Consideration of draft amendments to existing UN Regulations submitted by GRSP

Proposal for Supplement 8 to the 02 series of amendments to UN Regulation No. 129 (Enhanced Child Restraint Systems)

Submitted by the Working Party on Passive Safety *

Figure 1

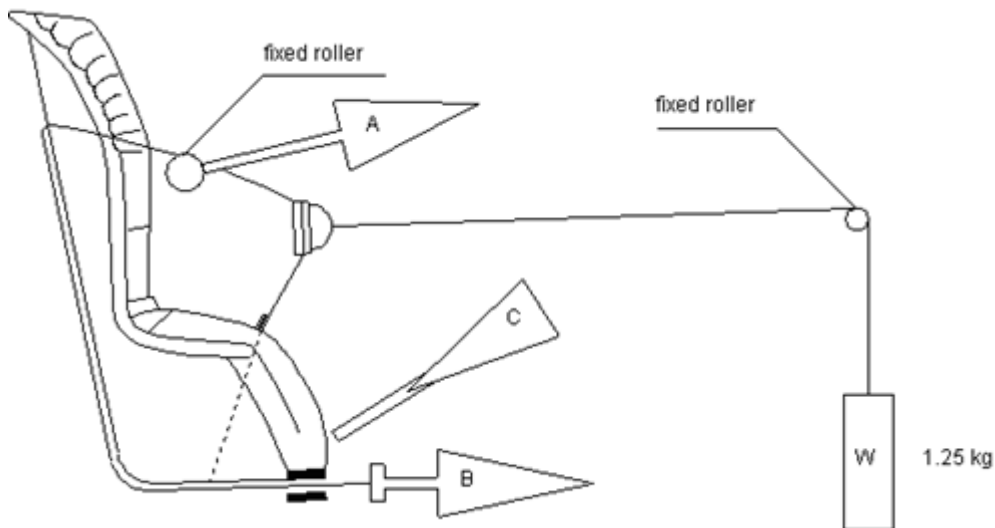
Annex 15, amend to read:

1. Conditioning for adjusters mounted directly on Enhanced Child Restraint Systems (Figure 1)
 - 1.1. Method
 - 1.1.1. With the webbing set at the reference position described in paragraph 7.2.6.1., withdraw at least 50 mm of webbing from the integral harness by pulling on the free end of the webbing.

- 1.1.2. Attach the adjusted part of the integral harness to the pulling device A.
 - 1.1.3. Activate the adjuster (C) and pull at least 150 mm of webbing into the integral harness. This represents half of one cycle and puts pulling device A to the maximum webbing extraction position.

- 1.1.4. Connect free end of webbing to pulling device B.
 - 1.2. The procedure of the cycle is:
 - 1.2.1. Pull B at least 150 mm while A exerts no tension on the integral harness.

- 1.2.2. Activate the adjuster (C) and pull A while B exerts no tension on the free end of the webbing.
 - 1.2.3. At the end of stroke, de-activate the adjuster.

1.2.4. Repeat cycle as specified in paragraph 6.7.2.7. of this Regulation.

Figure 2

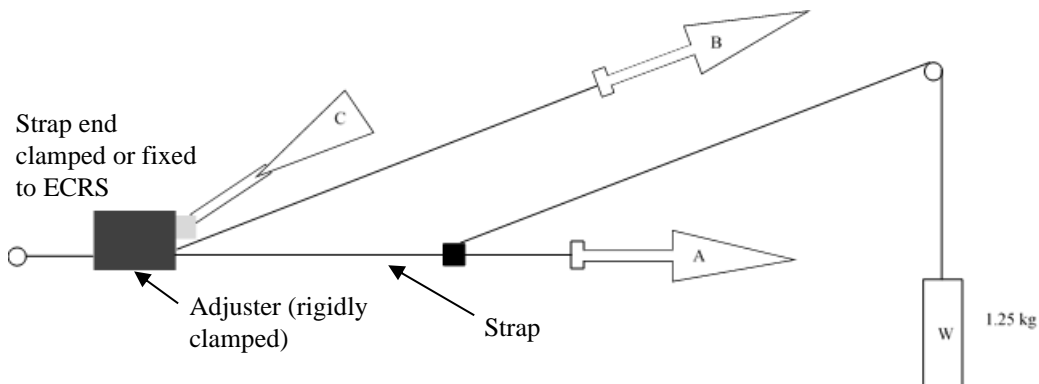
2. Conditioning for adjusters connected to a strap (not directly mounted on Enhanced Child Restraint Systems) (Figure 2)

2.1.1. Rigidly clamp the adjuster

2.1.2. With the strap set at the reference position described in paragraph 7.2.6.2., withdraw at least 50 mm of strap from the adjuster by pulling on the free end of the strap.

2.1.3. Attach the adjuster part of the strap to the pulling device A.

2.1.4. Activate the adjuster (C) and pull at least 150 mm of strap through the adjuster. This represents half of one cycle and puts pulling device A to the maximum strap extraction position.

2.1.5. Connect the free end of the strap to pulling device B.

2.2.1. Pull B at least 150 mm while A does not exert tension on the strap.

2.2.2. Activate the adjuster (C) and pull A while B does not exert tension on the free end of the strap.

2.2.3. At the end of the stroke, de-activate the adjuster.

2.2.4. Repeat the cycle as specified in paragraph 6.7.2.7. of this Regulation."
